ADDENDUM No. 5 – February 16, 2022

PART 1 - GENERAL

REFERENCE: H4.9
 DRAWING TITLE:
 Partial Level 2
 HVAC Piping
 Plan Section D

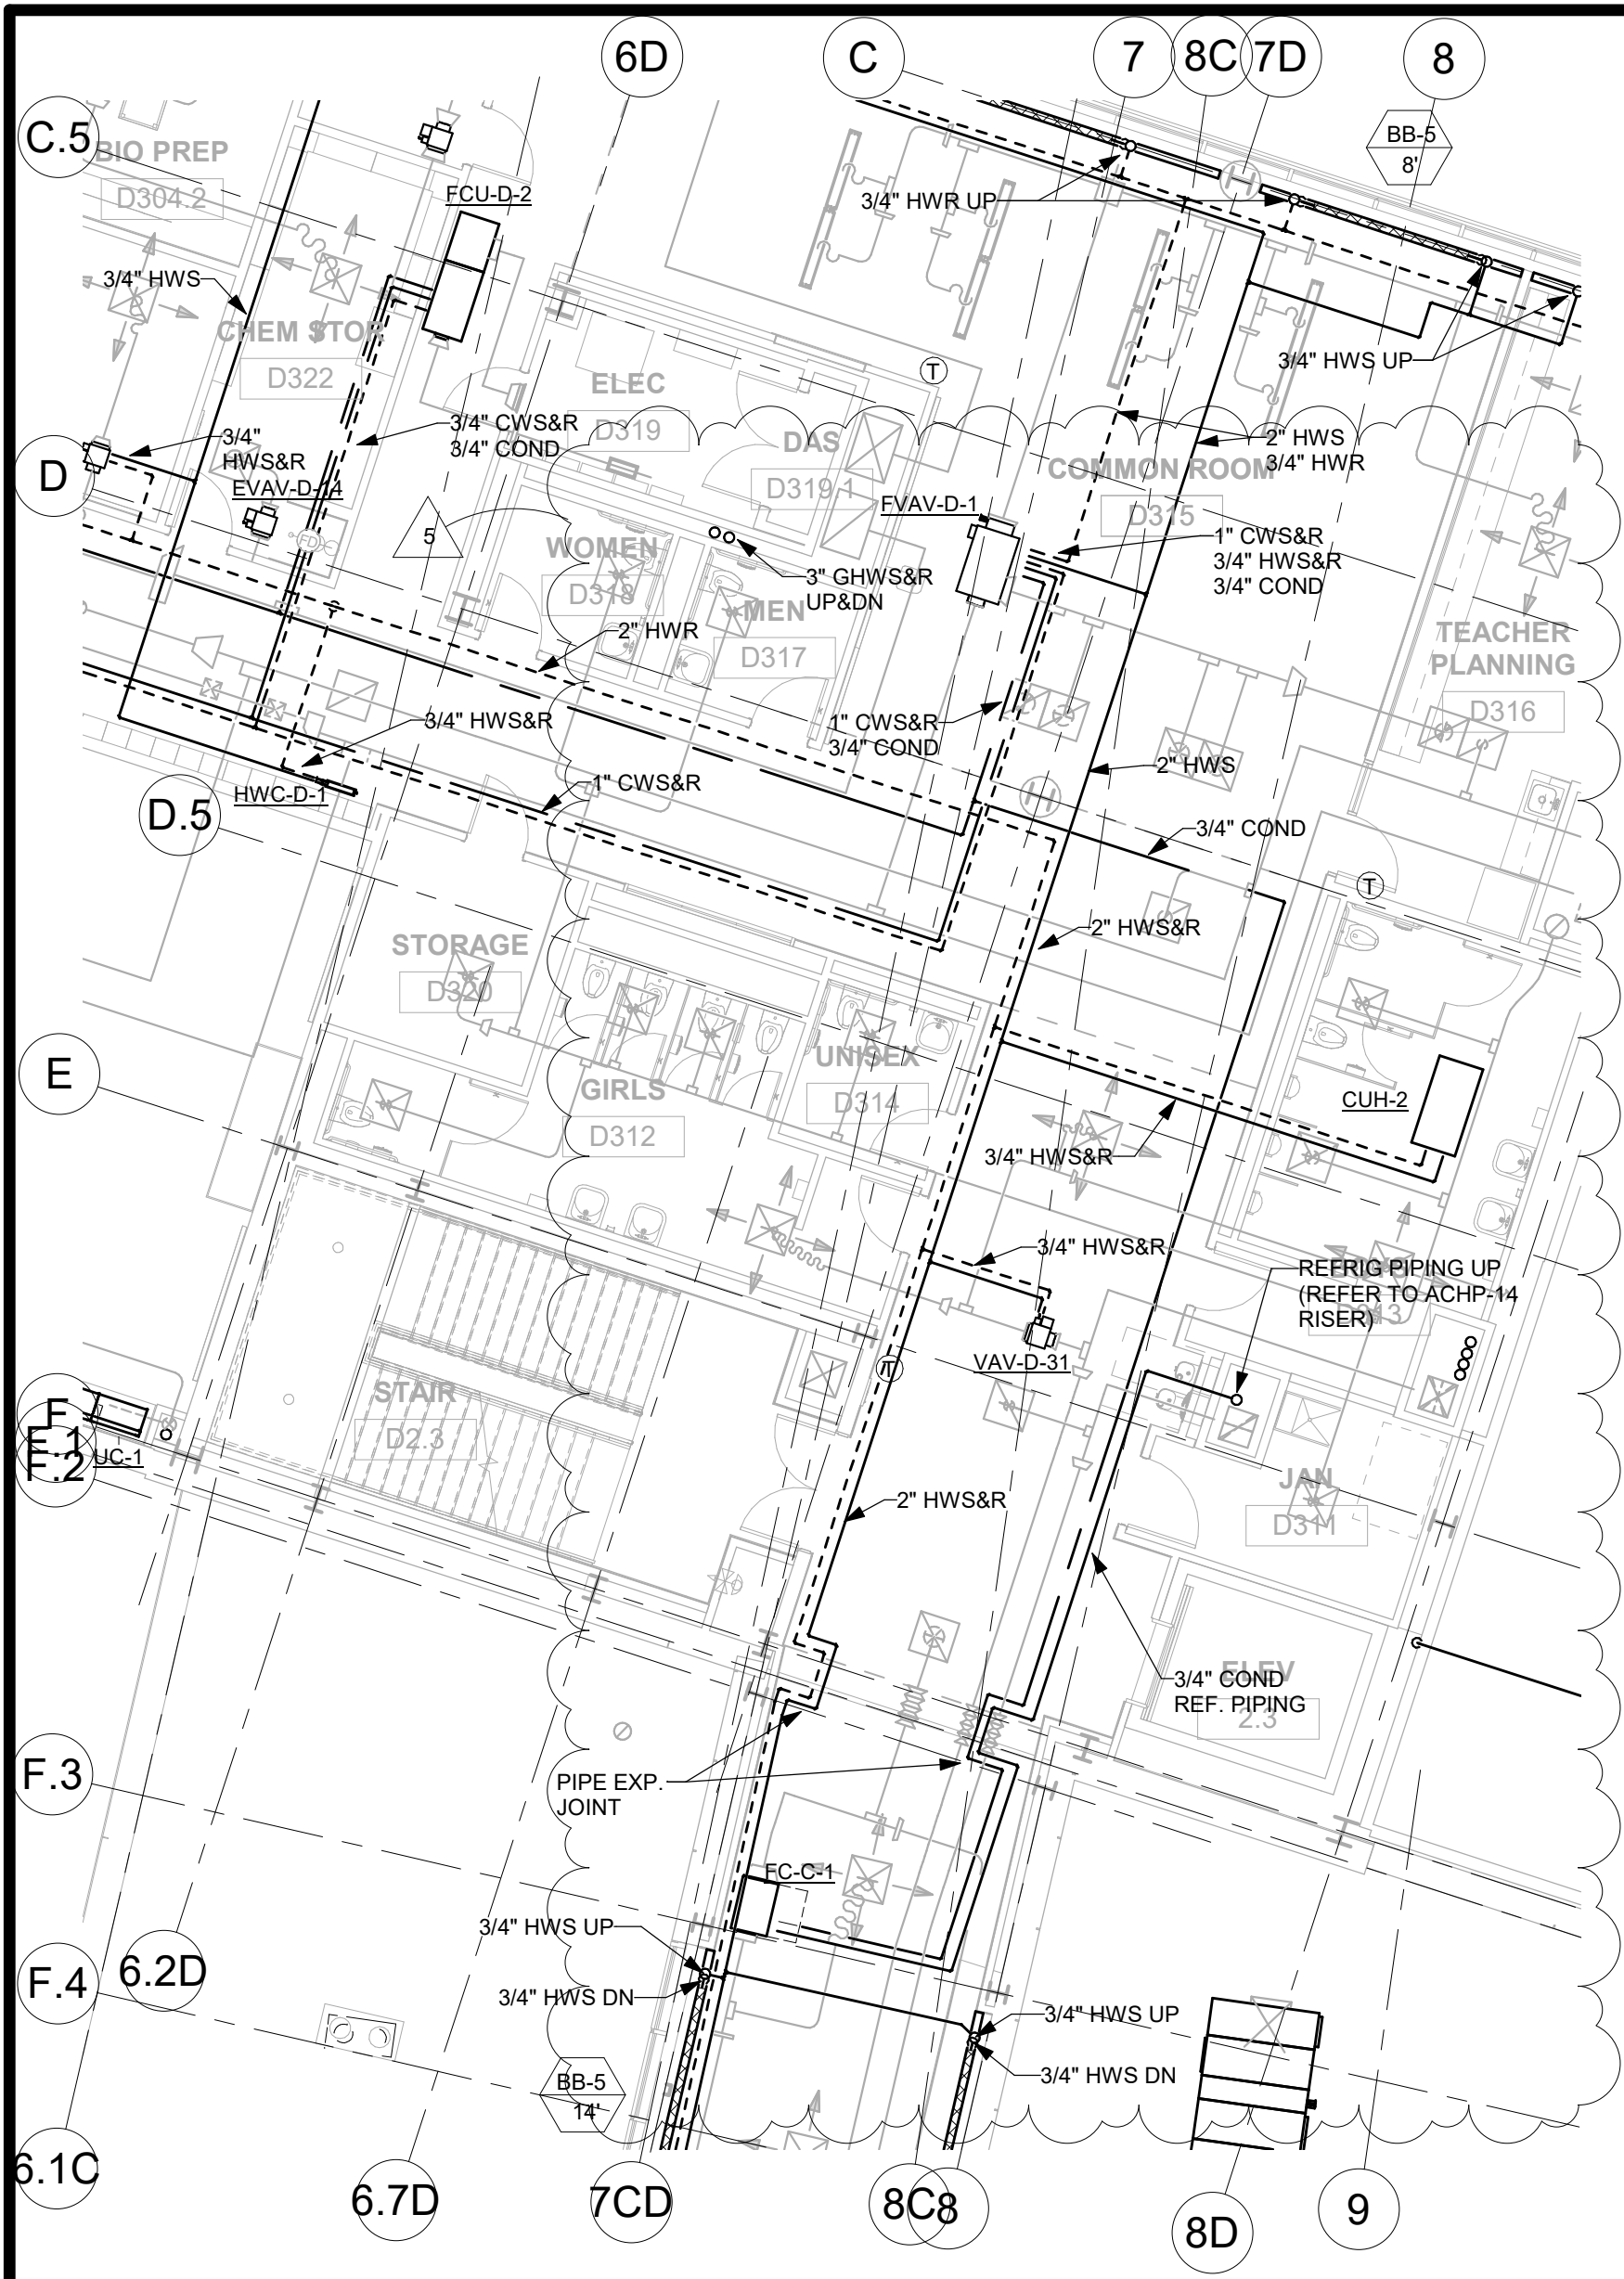
- A. In room C211 replace 24 feet of BB-1 with 18 feet of BB-2.
- B. Provide thermostats in the following additional areas: B210 (near column line N-7E.1), C200 (near column line J-2C), B200 (near column line J-5C), C203.4, C205, C212, D210 (near column line C.5-8), D210 (near column line F-7D), D210.1, D212, D213, D214.
- C. In rooms C215 & C217 add a CO2 sensor.
- D. In main corridor near column line 7D-F provide flexible connectors in supply ducts crossing building expansion joint from C to D building.
- E. In D222 Team Room area, tag the two VAV's according to the duct plan H3.9 such that the untagged VAV near column line B-3D is VAV-D-6 and the untagged VAV near column line B-4D is VAV-D-8.
- F. Connect the ¾" HWS and HWR branch lines in the area of VAV-D-6 and VAV-D-8 to these respective terminals.
- G. Refer to ADD-5/H013 Partial Level 2 HVAC Piping Plan Section D attached.

Partial Level 3
HVAC Piping
Plan Section D

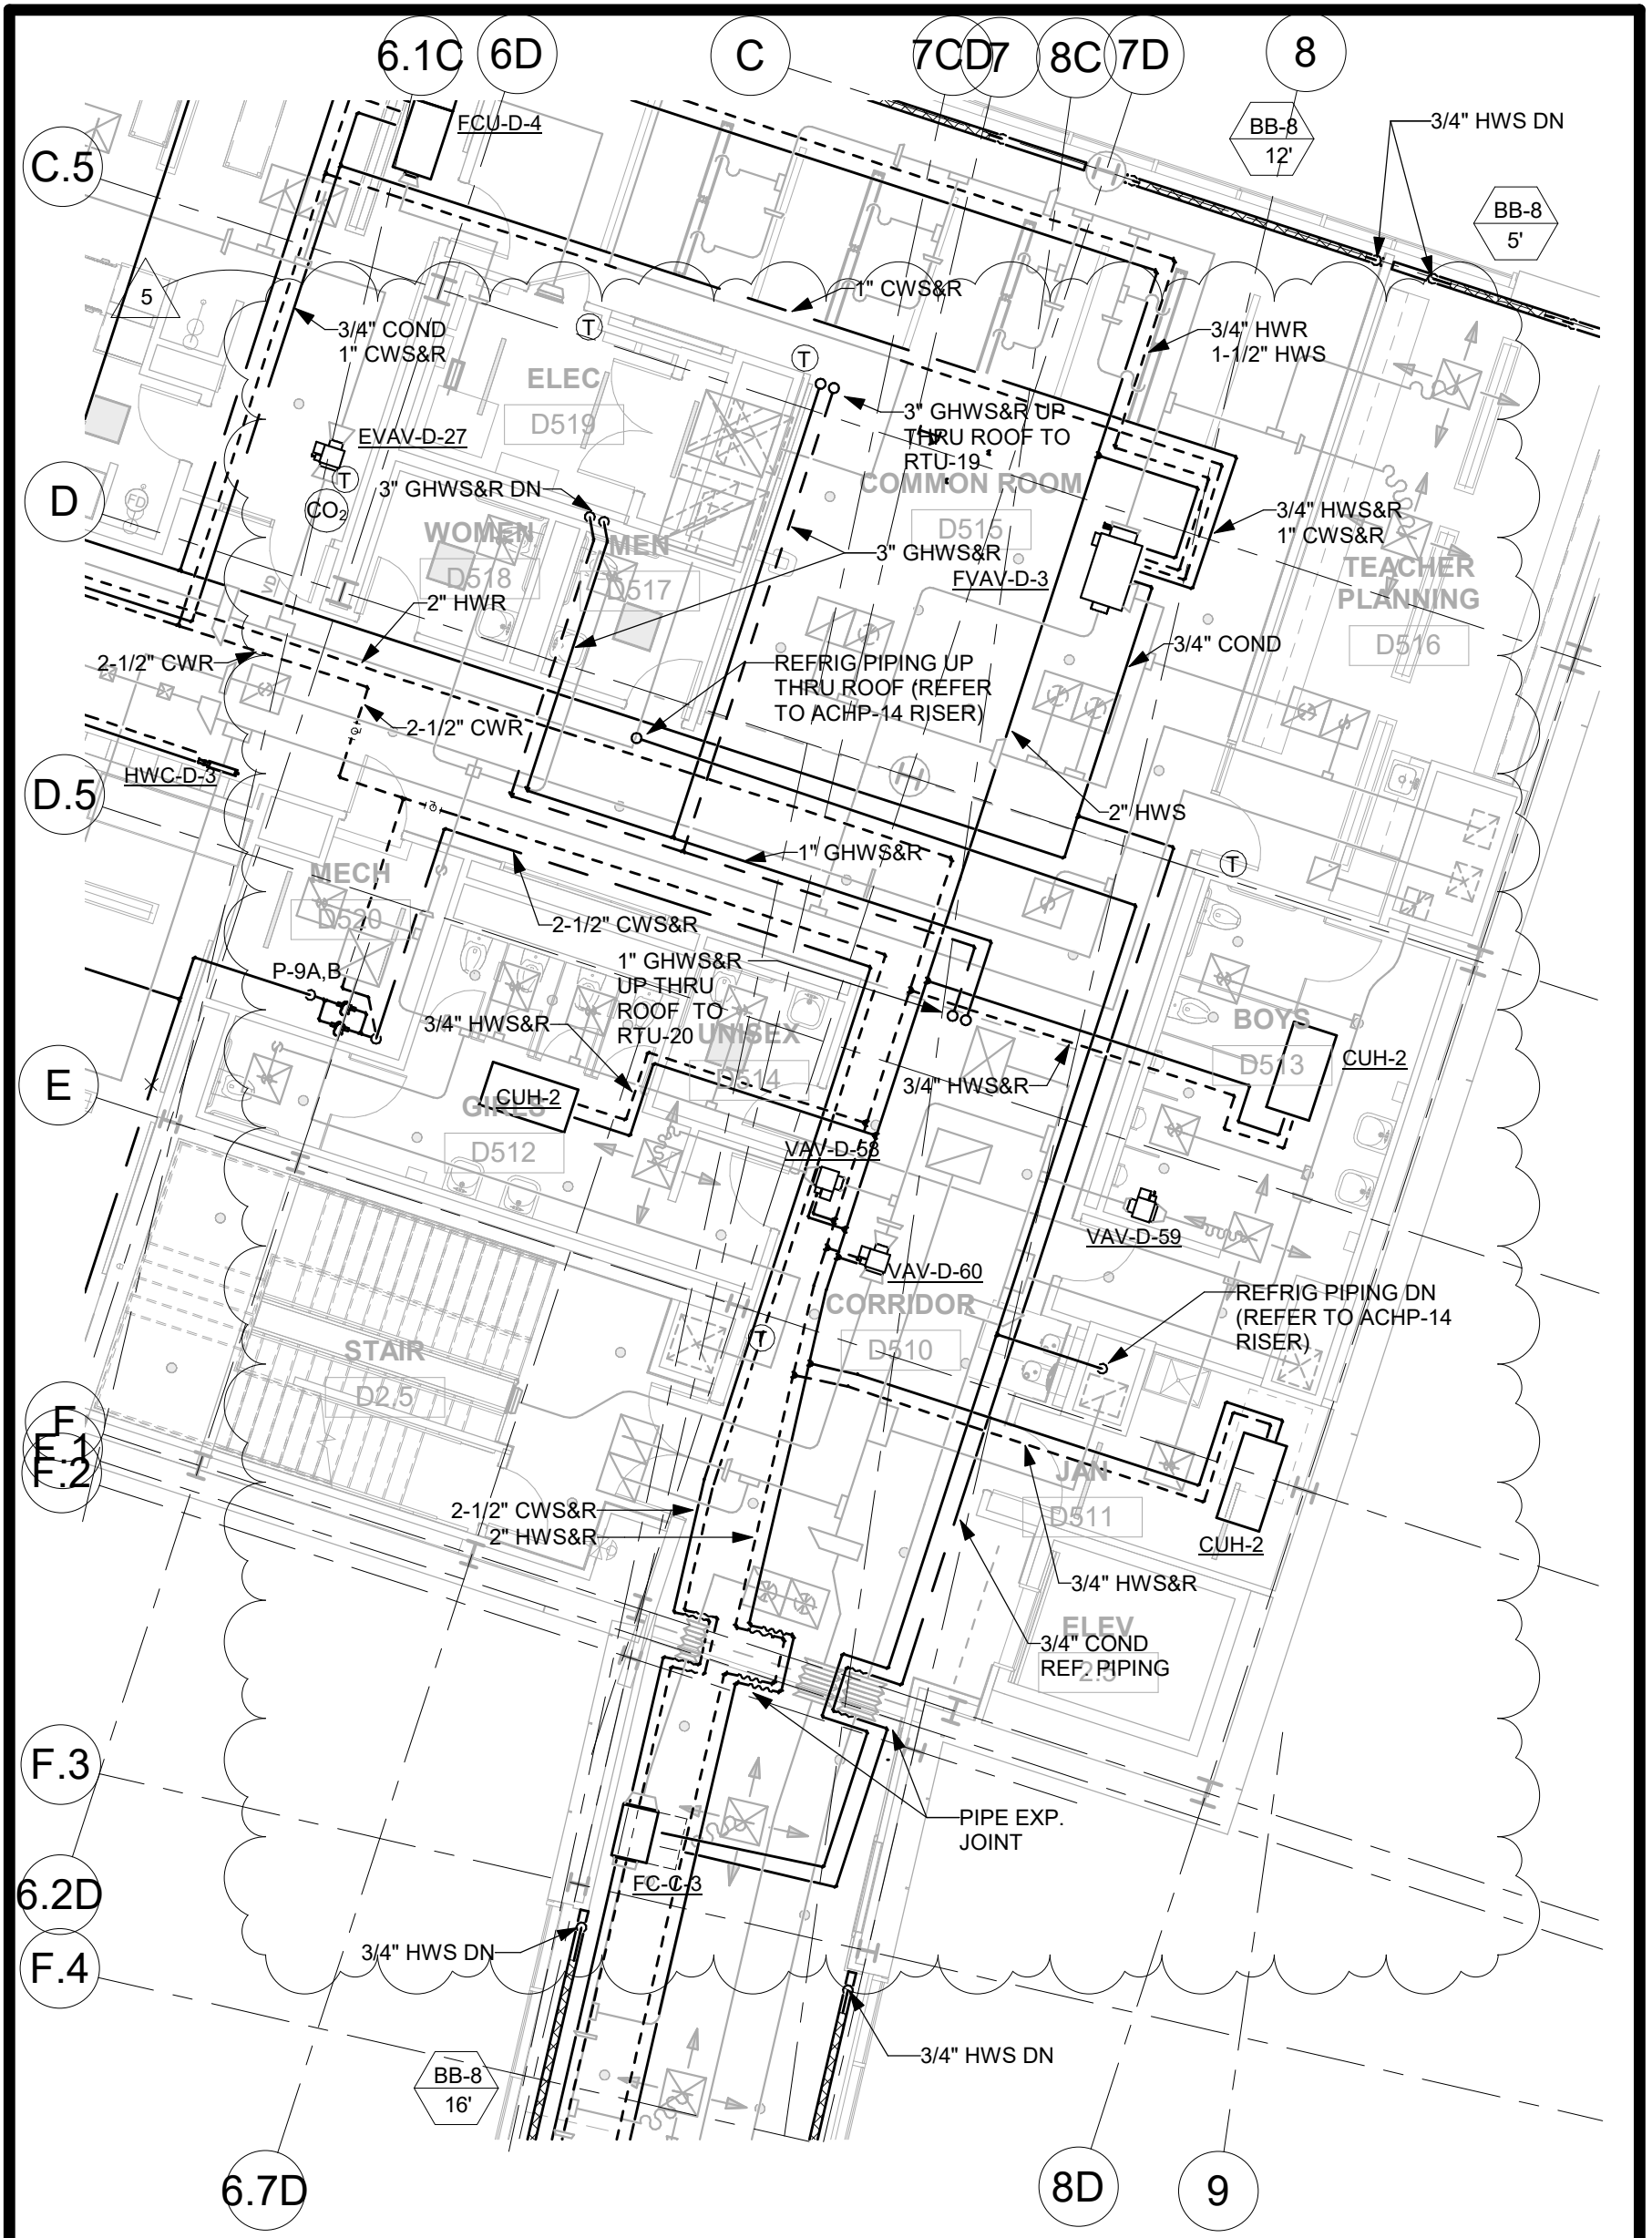
24. DRAWING H4.13 – Level 3 HVAC Piping Plan Section CD

Partial Level 5
HVAC Piping
Plan Section D

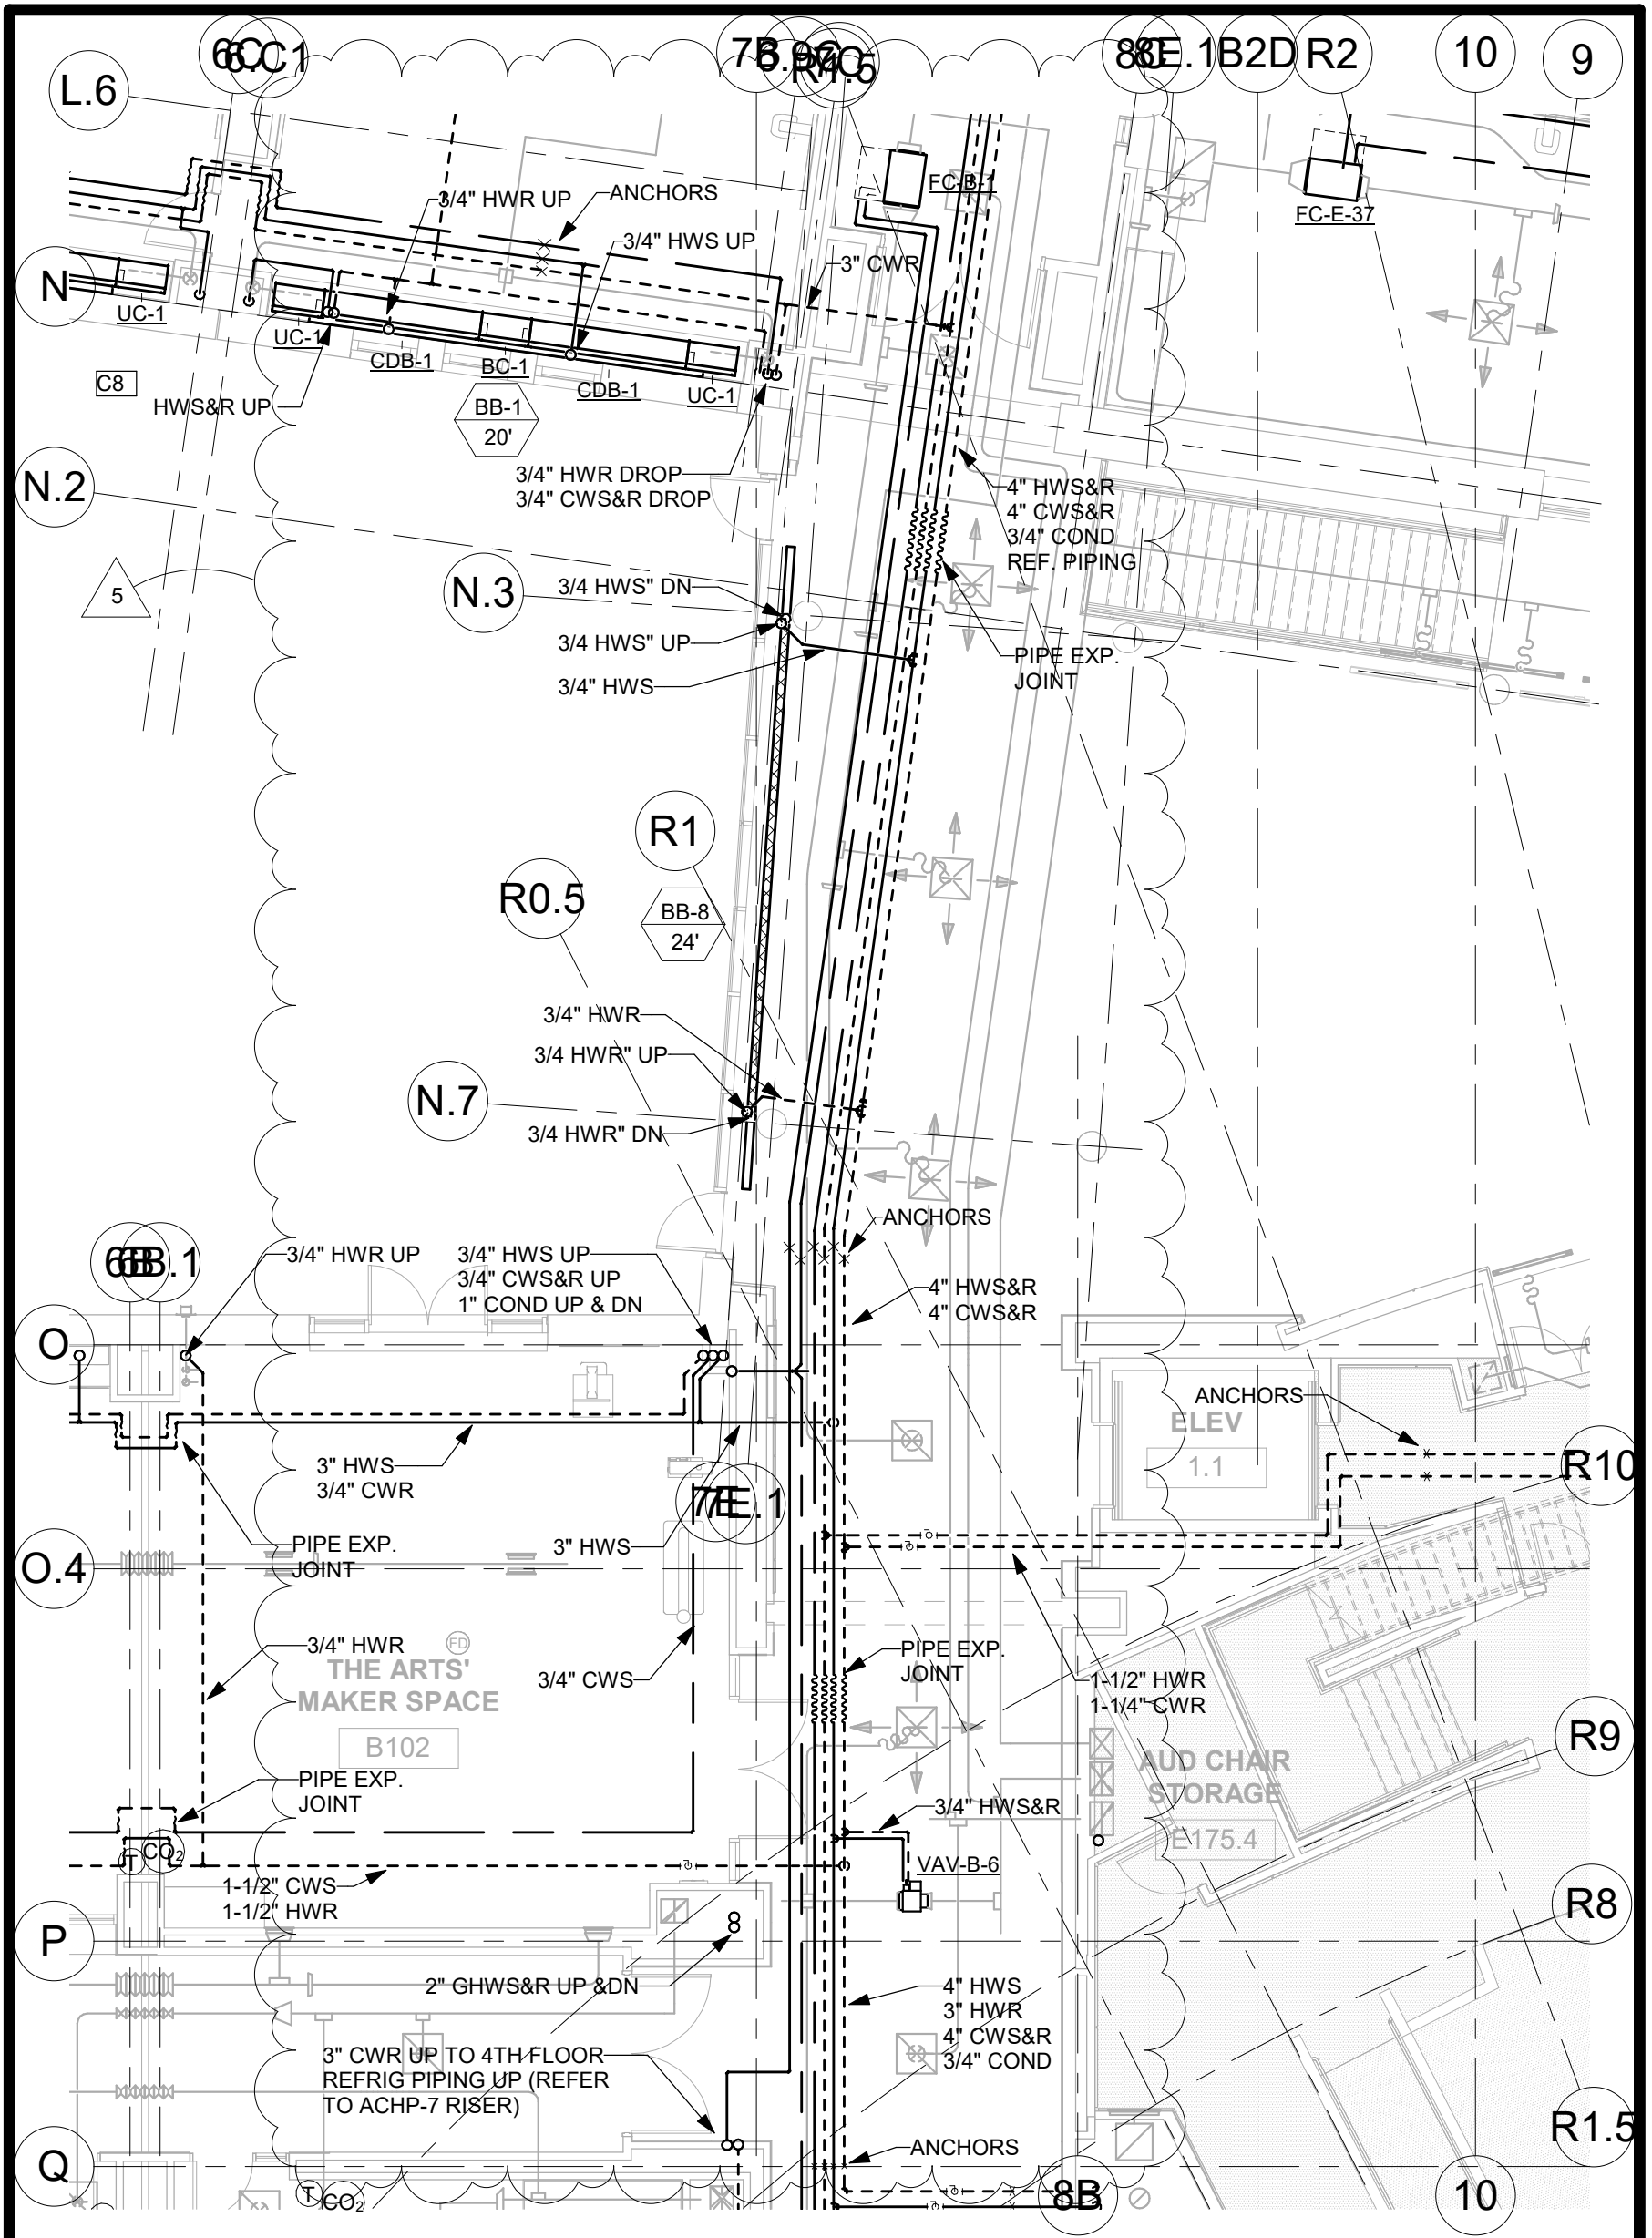
- A. In rooms D507 & D509 replace 24 feet of BB-1 with 18 feet of BB-2
- B. Provide thermostats in the following additional areas: Stair C1.5 (near column line I.2-2C), C500 (near column line J-2C), C500 (near column line J-5C), C501.1, C510 (near column line L-7C), C510 (near column line F-7), Stair D2.5 (near column line E-6.7D), D500 (near column line D-2D), D500 (near column line D-5D), D511, D512, D513, D520.
- C. In D515 add a CO2 sensor.
- D. Refer to ADD-5/H016 Partial Level 5 HVAC Piping Plan Section D attached.
